AGENDA
La Vergne Planning Commission
July 25, 2023 at 6:00 PM

Item Title: Site Plan - Marlowe La Vergne - 376 Apartments on 27.49 Acres. Requested by Kimley Horn. Property located at 243 Blair Road (Tax Map 32, Parcel 6). R-3 (High Density Residential) Zoning District. Property owned by Martin Shofner. (Deferred by Applicant)

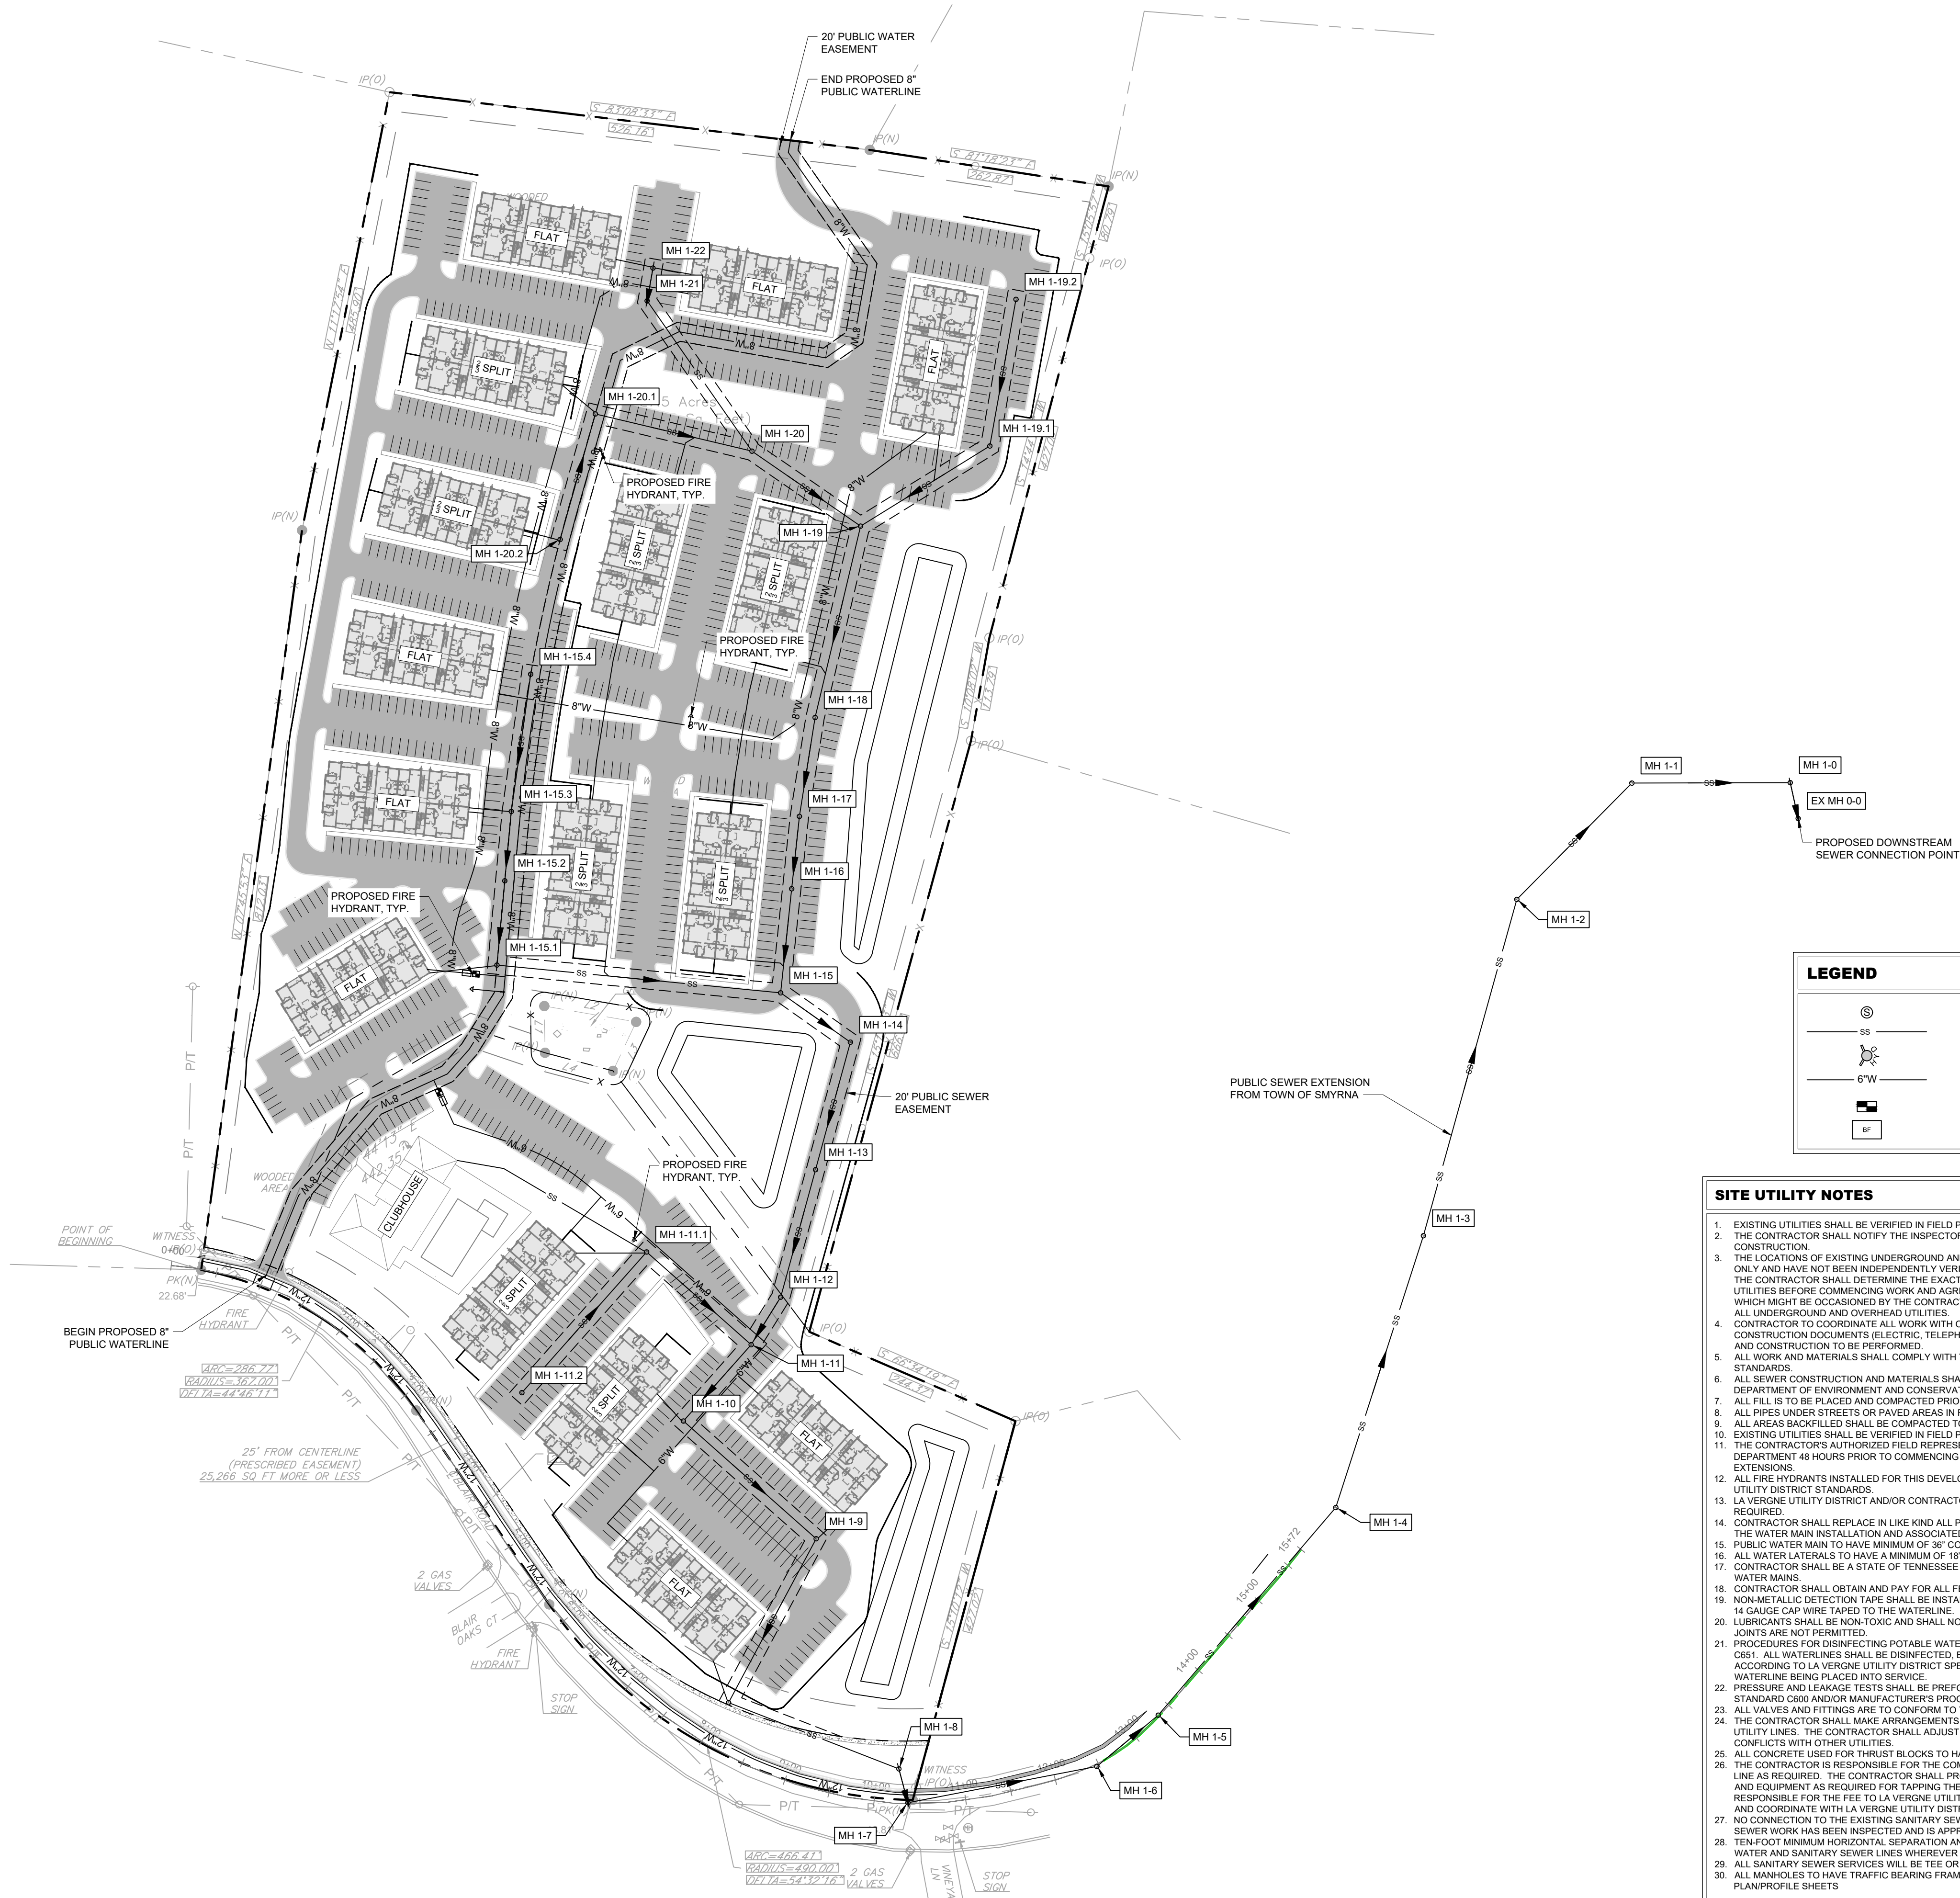
1. Water availability letter will be written by the City's consulting engineer. Fire flow test was requested on May 10, completed and returned on May 26, 2023. Result was 2,603 gpm at 20psi in the 6" waterline in Blair Rd.
2. Sewer availability letter will be written by the Town of Smyrna. This property is within the boundaries of the Interlocal Agreement – Blair Rd Drainage Basin – 2018-02, so sewer will flow to Town of Smyrna collection system. The current nearest point of connection is near 303 Blair Rd.
3. Sht C4-00 "Grading and Drainage Plan" shows Bldg 2C with FFE = 778.50', but roadside grades of 750', a 28-foot difference. Sewer is shown to run right through this location of a rather high retaining wall. La Vergne standards do not allow for sewer greater than 20' deep.

C1.0

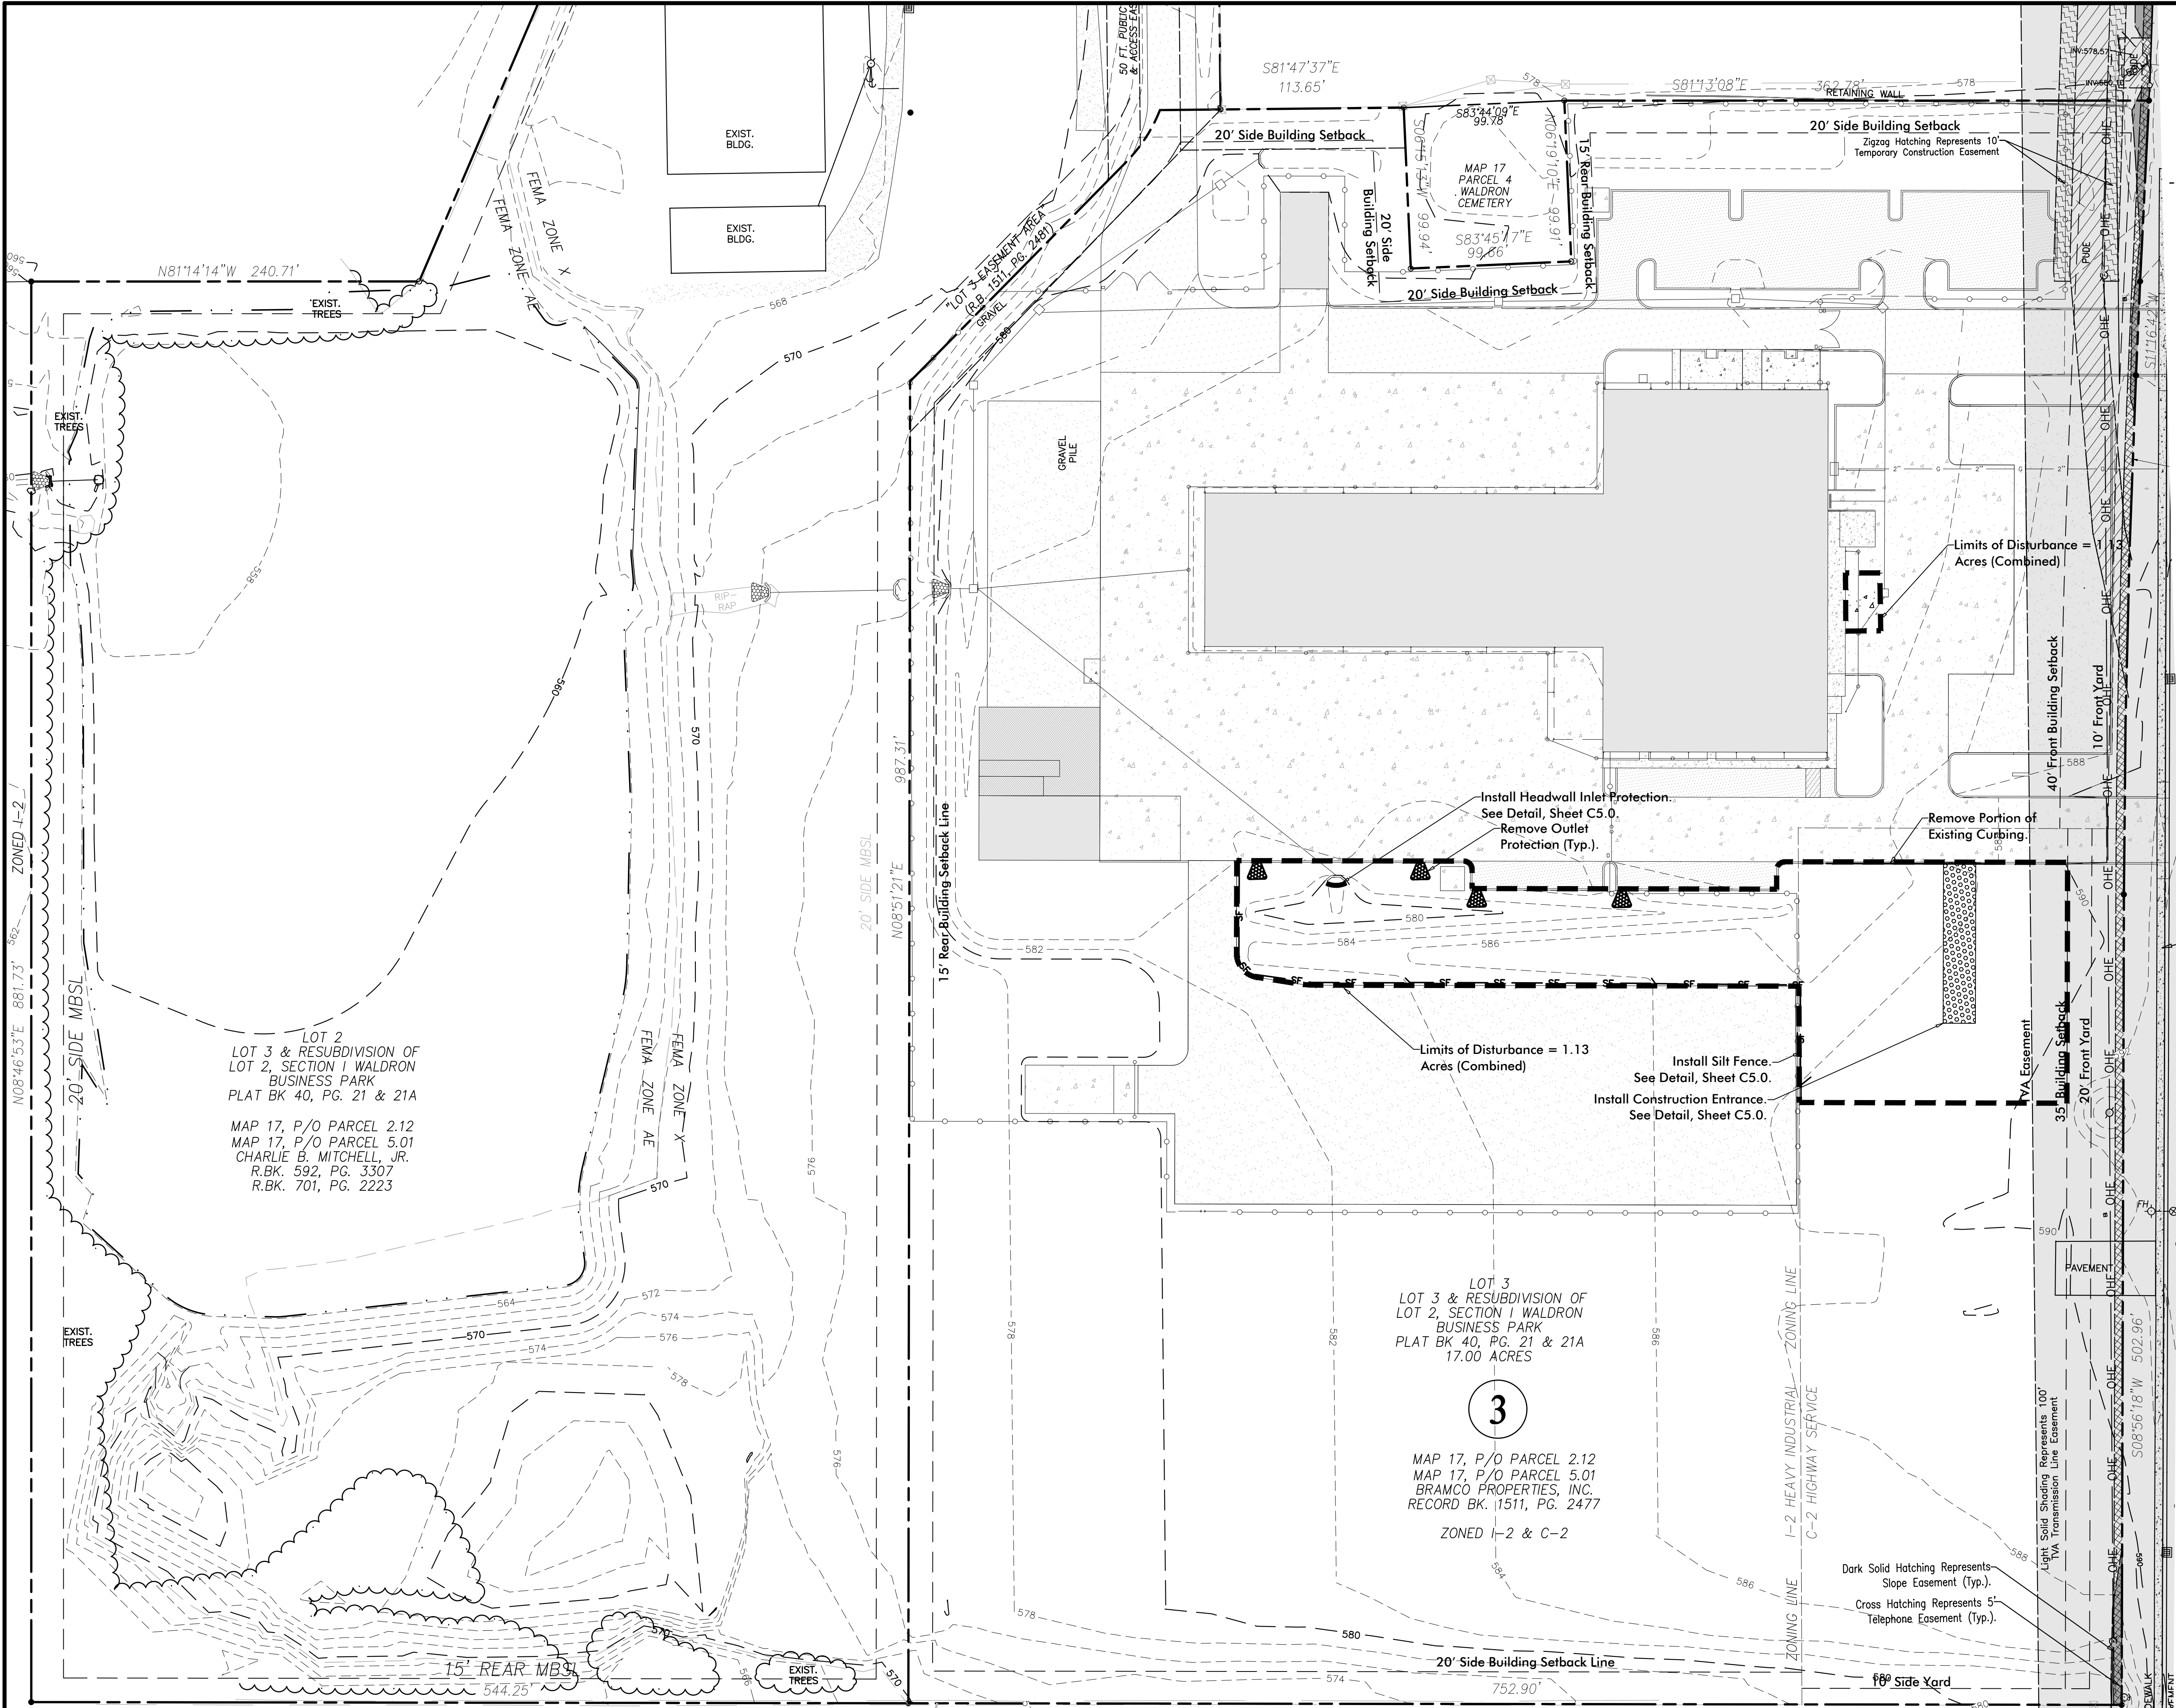
- 1 (Sheet C1.0) Provide dimension from ROW of Waldron Road to edge of new parking area. Provide width of island between new parking area and existing drive. Provide dimensions sufficient to field locate Rental Ready Expansion area.
- 2 (Sheet C1.0) Confirm that additional handicap spaces are not required with this parking expansion.
- 3 (Sheet C1.0) Provide dimensions of parking spaces and travel lanes in parking area.
- 4 (For information) Loading dock addition will require

DUSTLESS SURFACE AREA

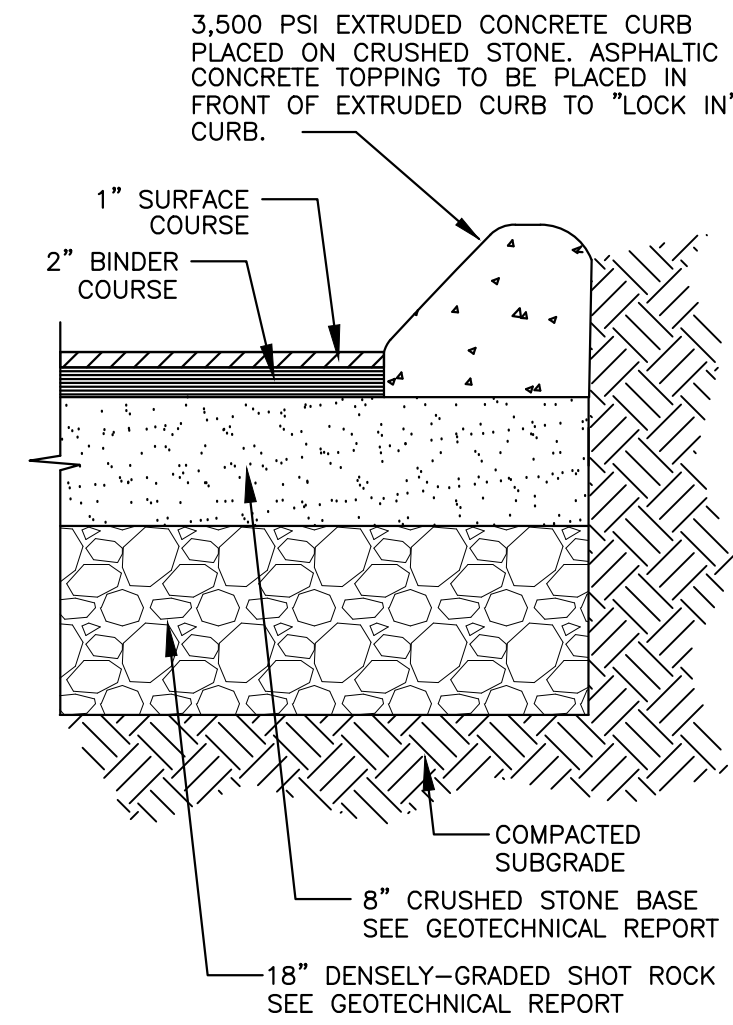
5 (Sheet C5.0) The Planning Commission interprets a dustless surface as, at a minimum, a DBST section meeting the requirements of TDOT Specifications 405.06B. The "Dustless Surface Area" section shown is an SBST and does not meet this criteria.
